Access Compliance Report Public Rights-of-Way (Curb Ramps)

Main Street: ARROYO_AVE		Cross Street: TREASURE_LN		Location:	E
ADA ID: RPRK220125140614	Ramp Type: Type 4 - Parallel	Initial Pass/Fail: Fail	Overall Compliance: No	Severity Score:	15

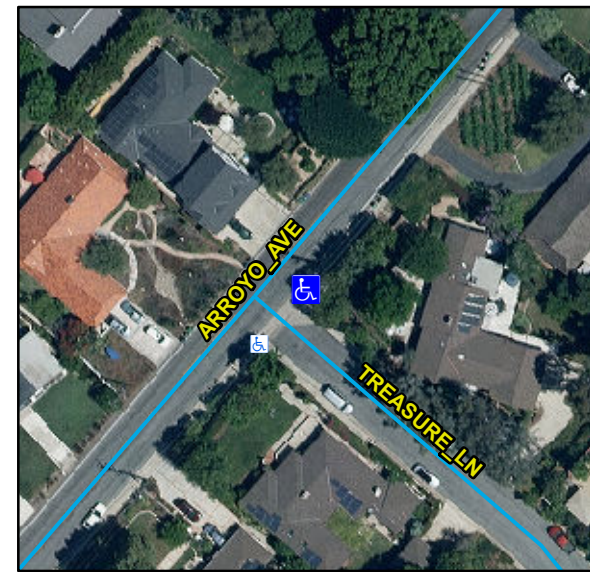
Remove & Replace Curb Ramp With Two New Directional Ramps or Equivalent.
